# 50cc Sport Cub S2 Addendum

This addendum will cover the following issues for the 50cc Sport Cub S2.

## Step #1 Page 34

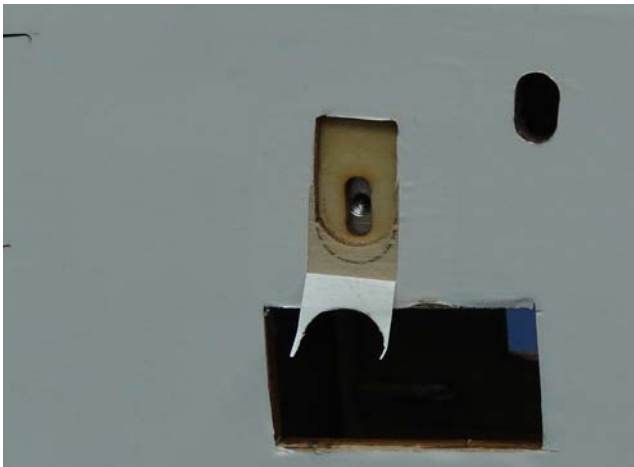
The removable wooden spacer in the front L bracket mounting location has been covered over. If you wish to remove this tab as shown in the manual the covering will need to be removed. Follow the remaining steps in the manual once the covering has been removed.

## Step #1 Page 22 Part B

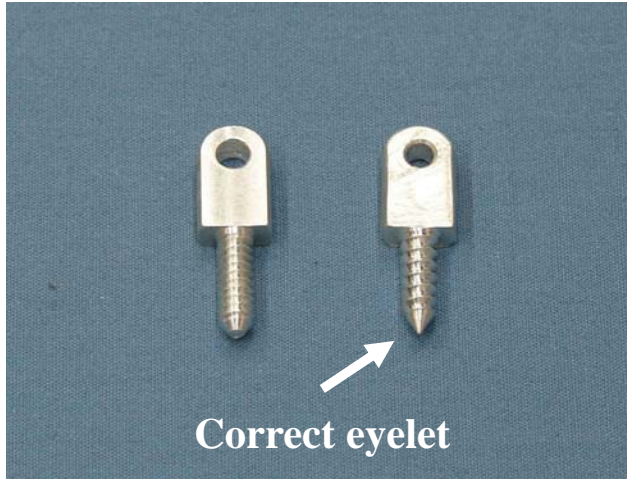
1. (12) #2x8mm wood screws have been included with this addendum. It is the builder's choice to use these screws or the bolts shown above. Follow the steps in the manual if using these mounting screws.
